# MEMO

**To:** Kristopher Byrd, Well Construction and Compliance Section Manager  
**From:** Travis Kelly, Well Construction Program Coordinator  
**Subject:** Re-Review of Water Right Application LL-1783  
**Date:** June 25, 2020

Application # LL- 1783

TO: Water Rights Section Date 6/16/2020  
 FROM: Groundwater Section Benjamin Scandella, Jen Woody  
 Reviewer's Name  
 SUBJECT: Application LL-1783 Supersedes review of 6/7/2019  
 Date of Review(s)

YAMH 57912

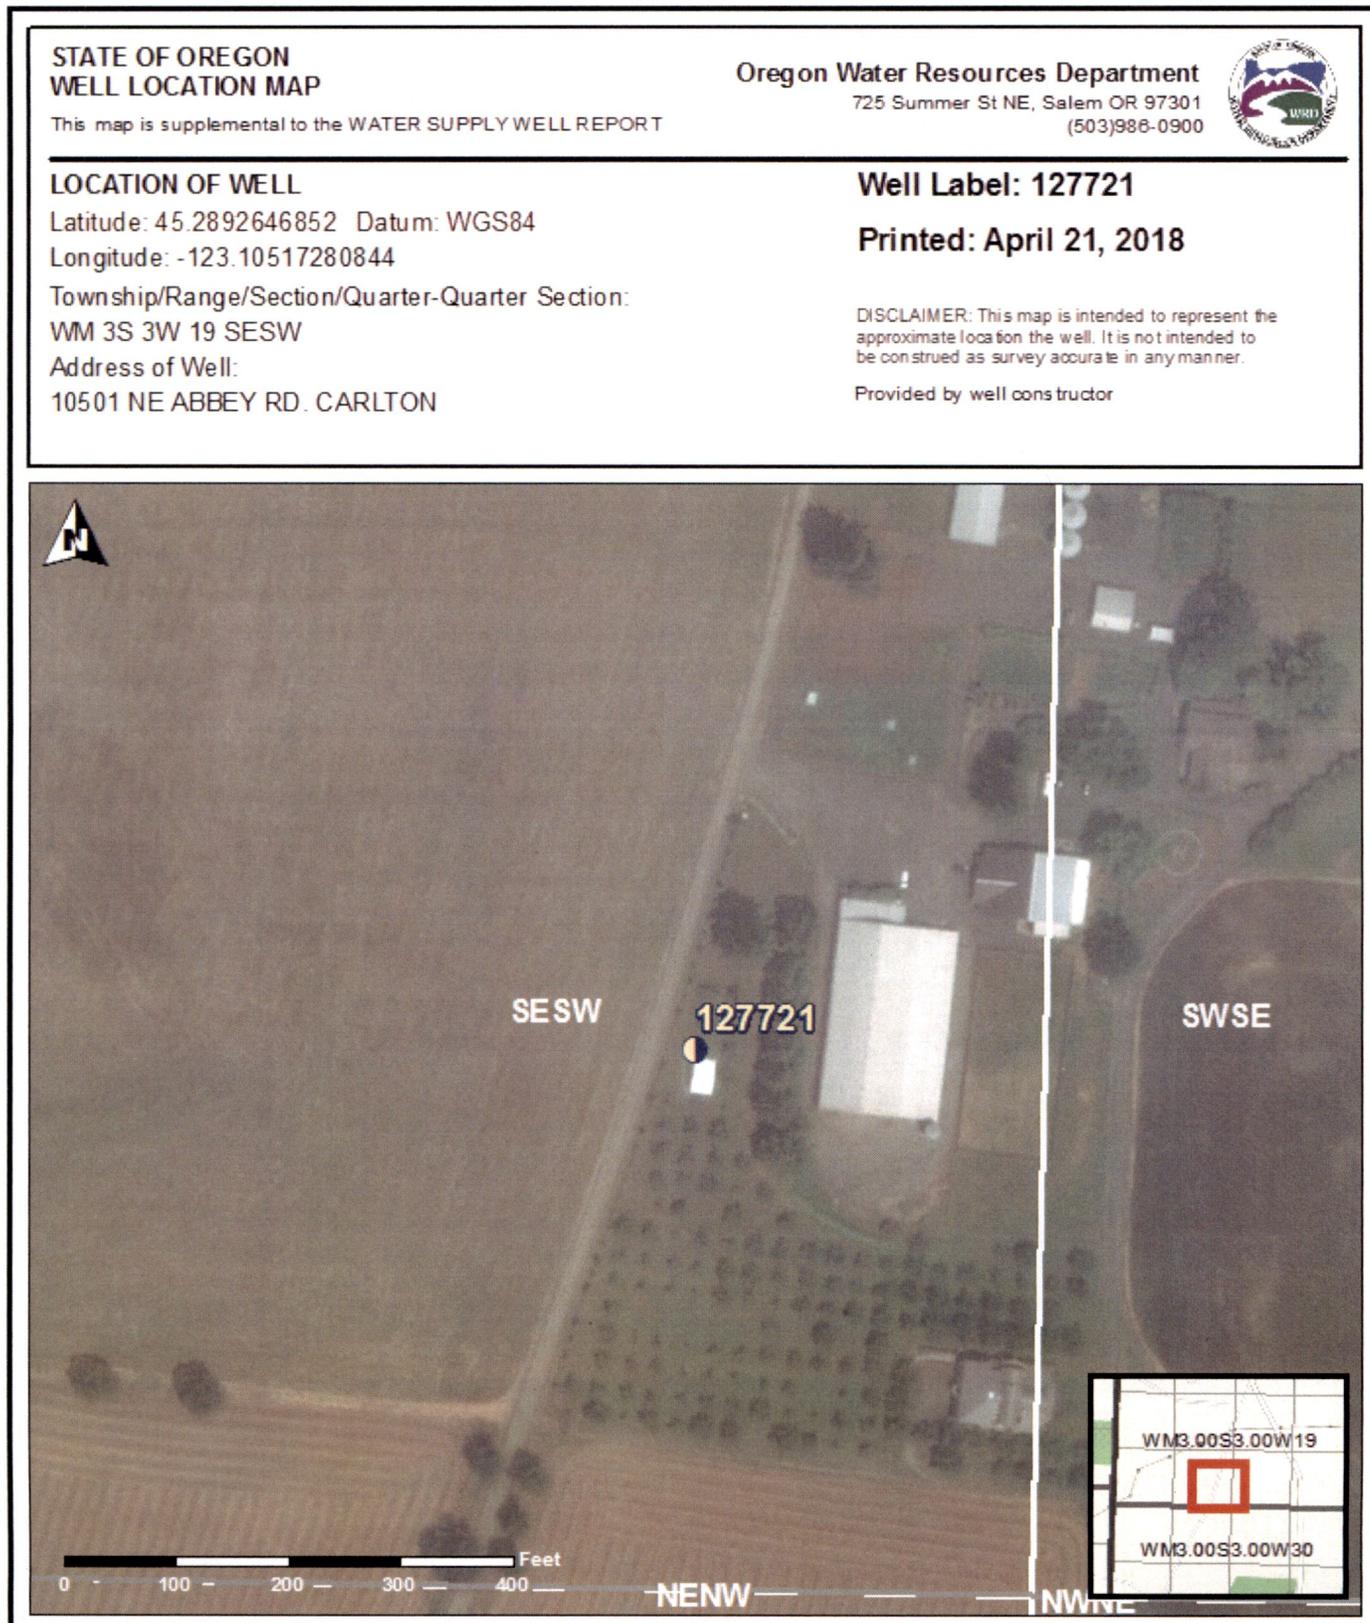
Applicant's Well #2 (YAMH 57912): Based on a review of the Well Report, Applicant's Well #2 seems to protect the groundwater resource.

The construction of Applicants Well #2 may not satisfy hydraulic connection issues.
